Addendum No. 1
April 29, 2019

Project: First PREMIER Bank
Bid Package #2
Sioux Falls, South Dakota
#2764

Architect: Architecture Incorporated

DETAIL 4/5.49

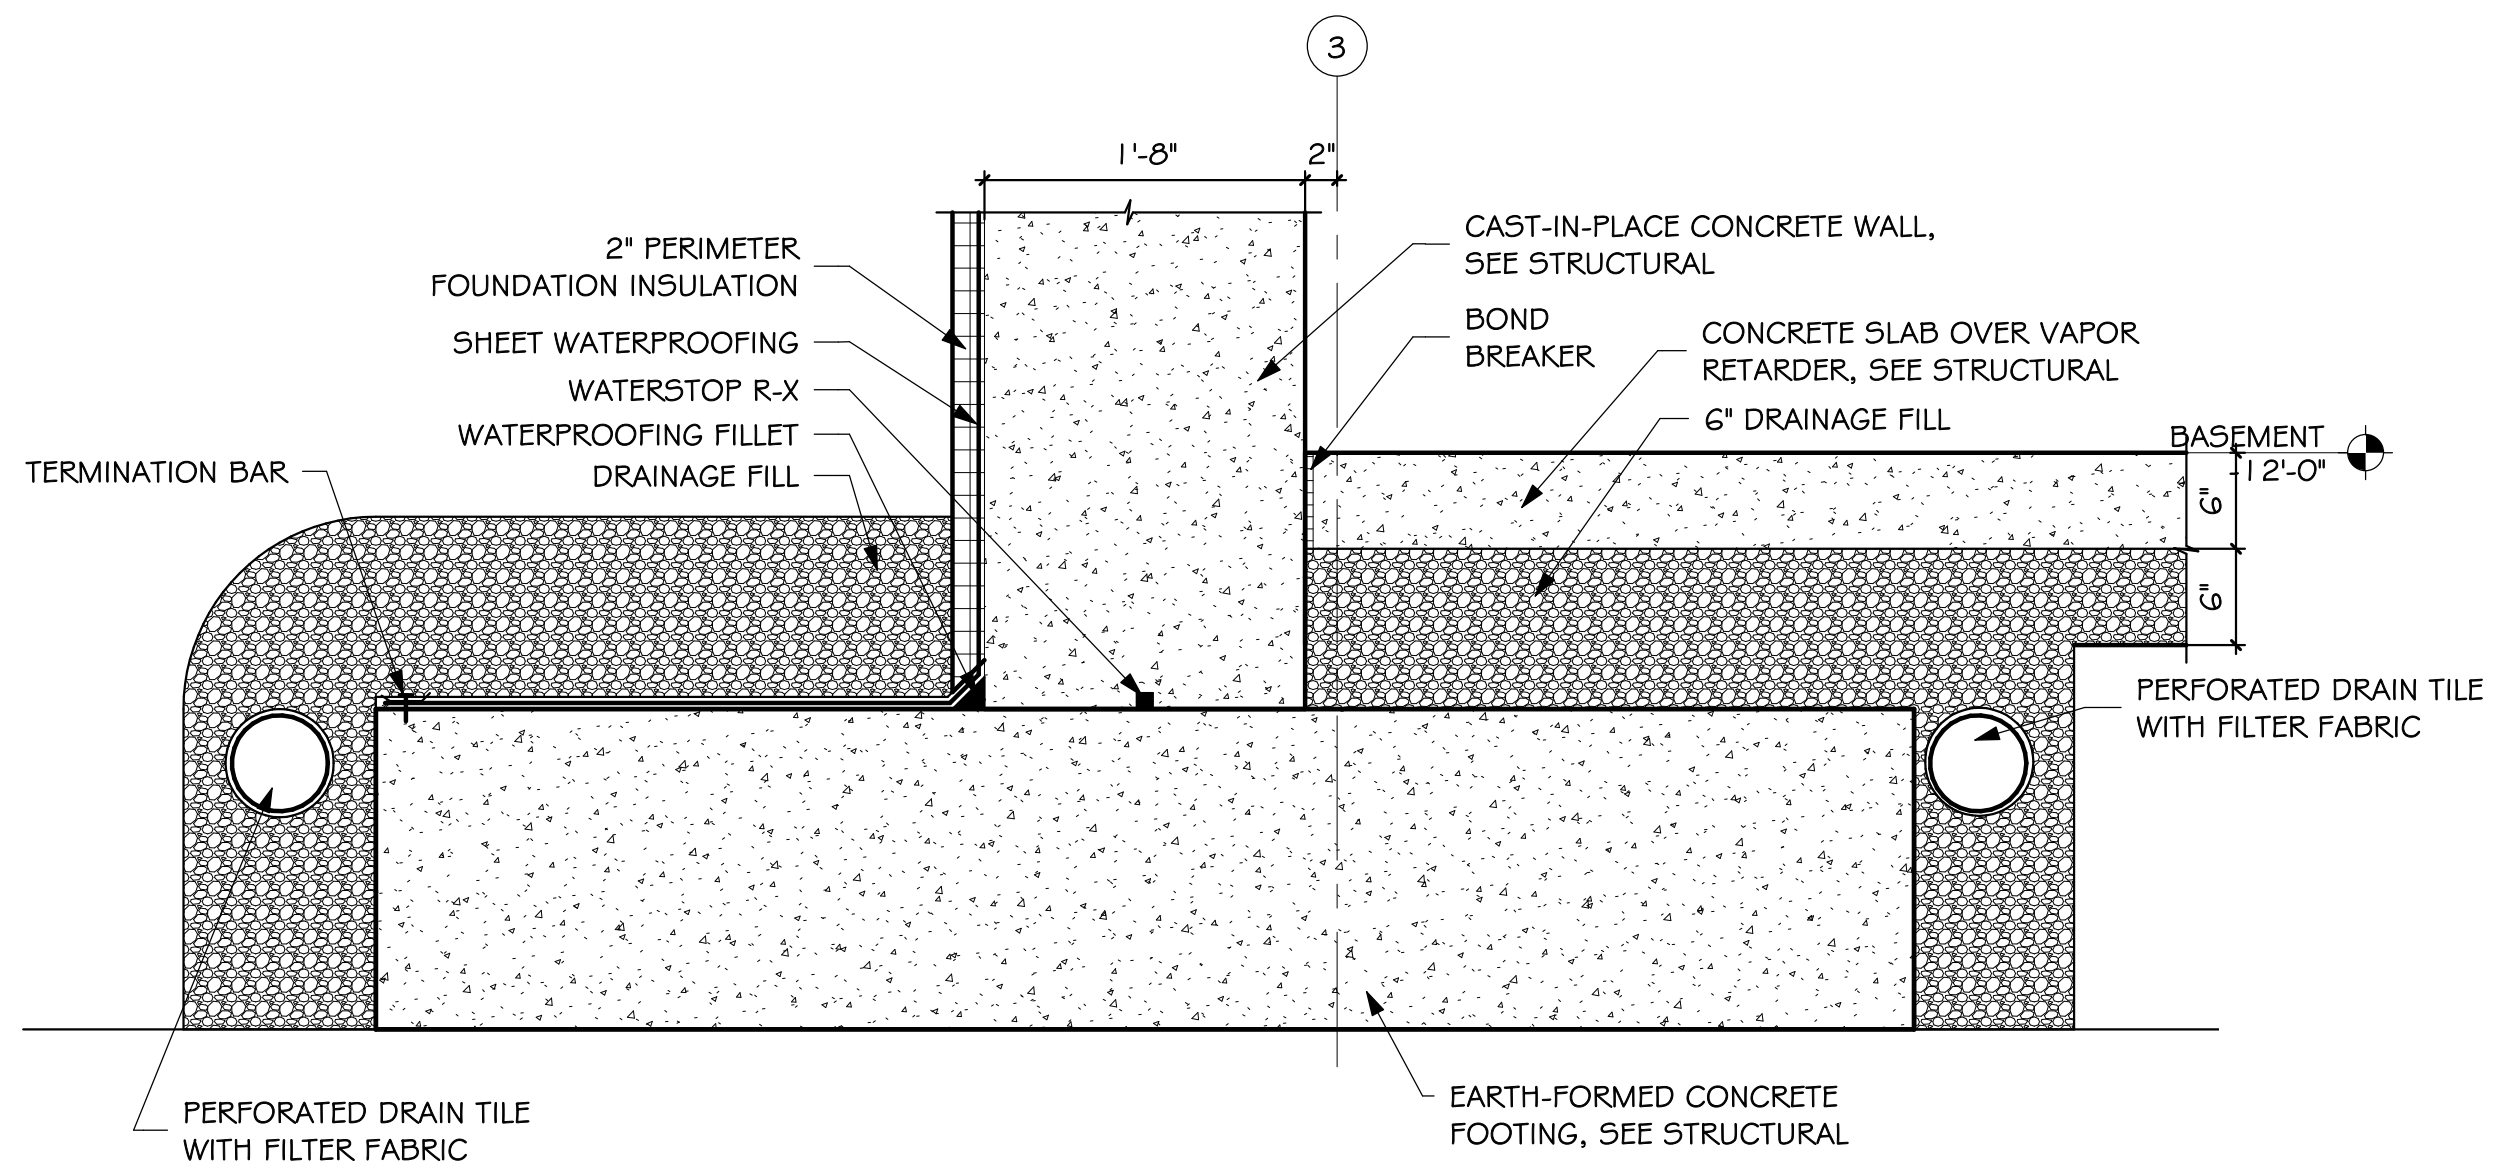
- a) Reference drawing SD-1 dated 04/25/2019 for changes to detail 4/5.49. This detail shows typical foundation wall/footing waterproofing and draitile modifications. The top of the draitile shall be no higher than the top of the footing. Furnish and install a termination bar for the waterproofing membrane at the footing.

1
SD-2
DETAIL - REVISED 6/4.38
 SCALE: 1 1/2" = 1'-0"

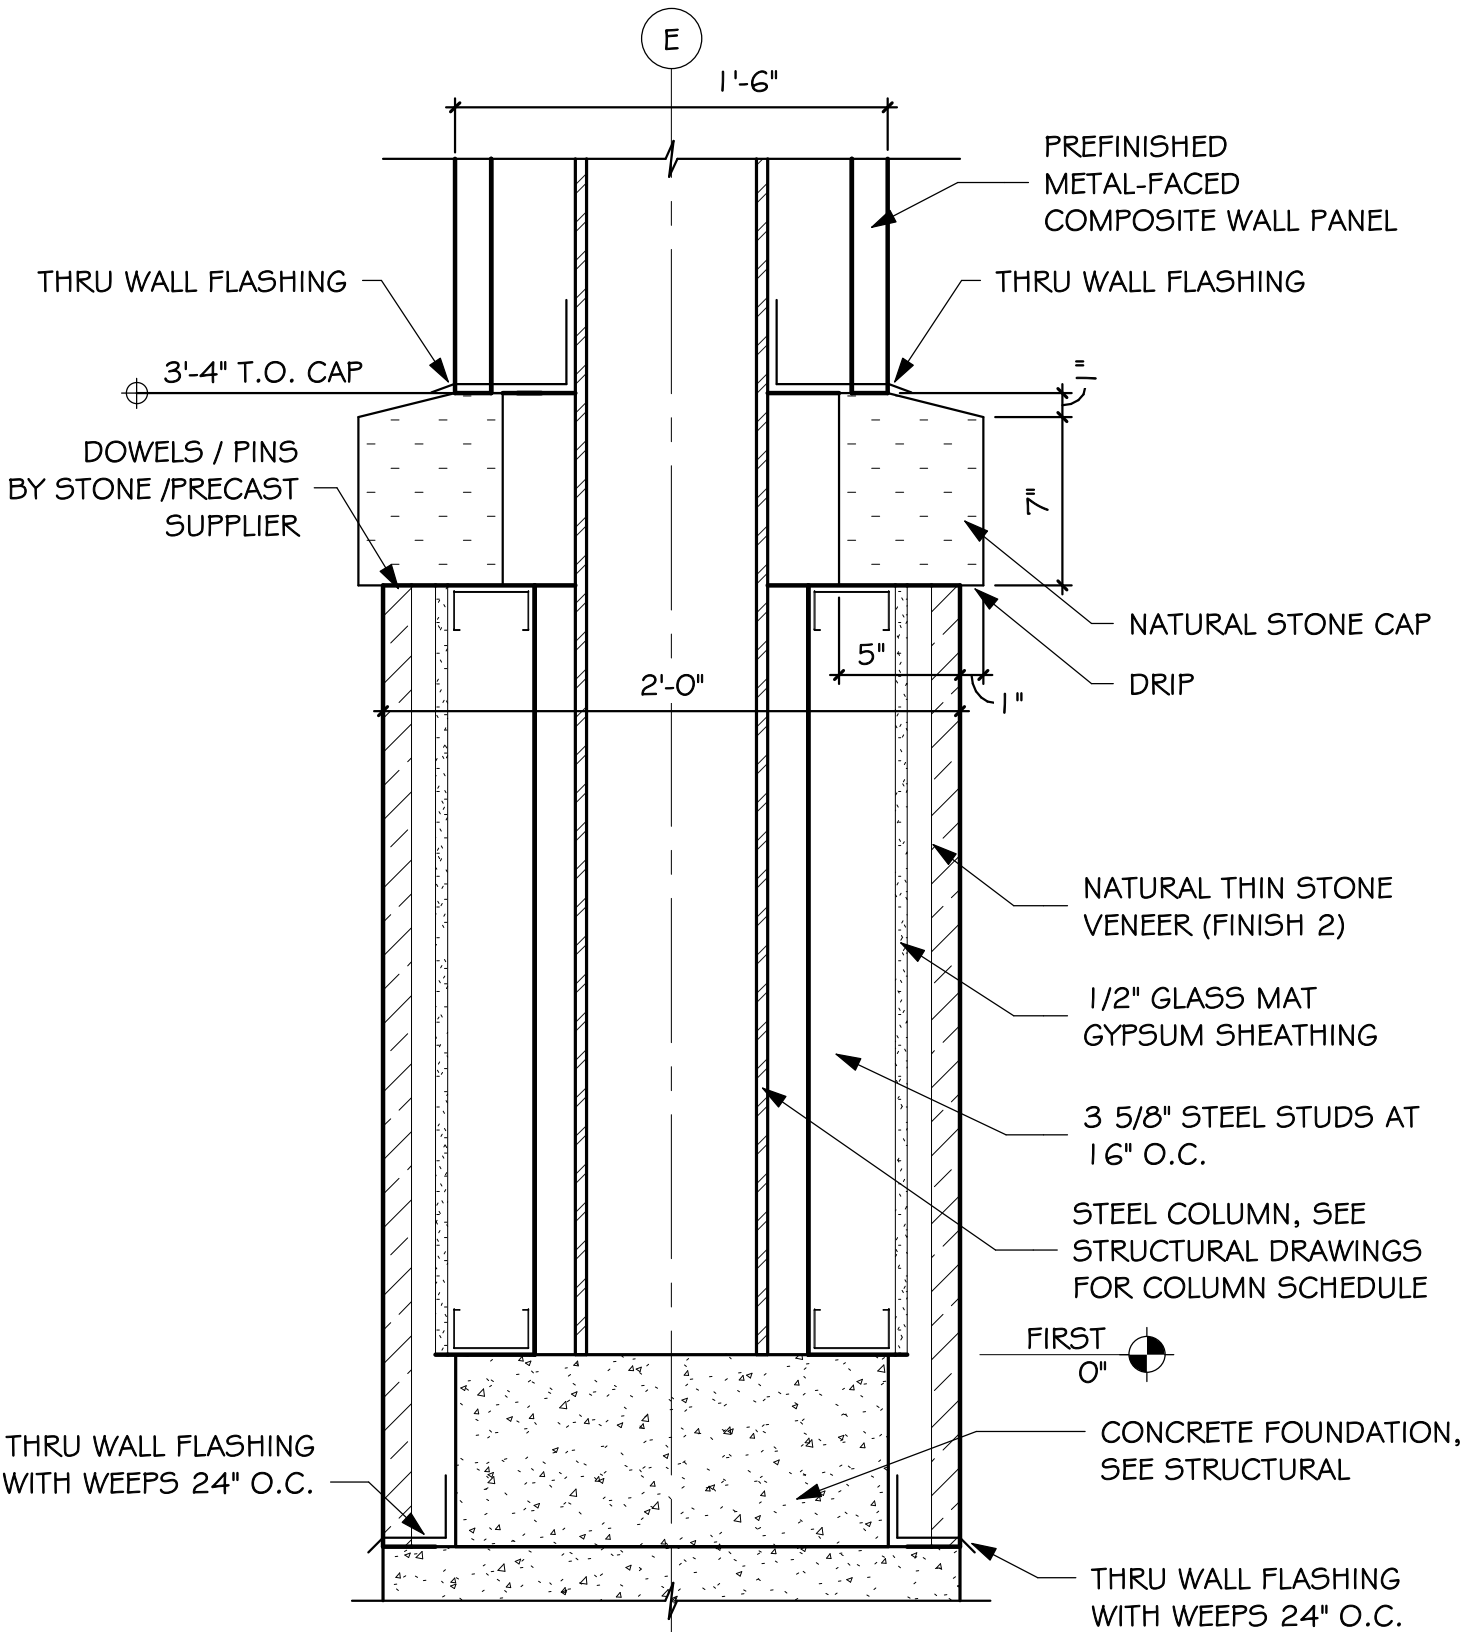
- a) Detail 6/4.38 – Reference attached SD-2 dated 04/25/2019 for revisions to detail 6/4.38.
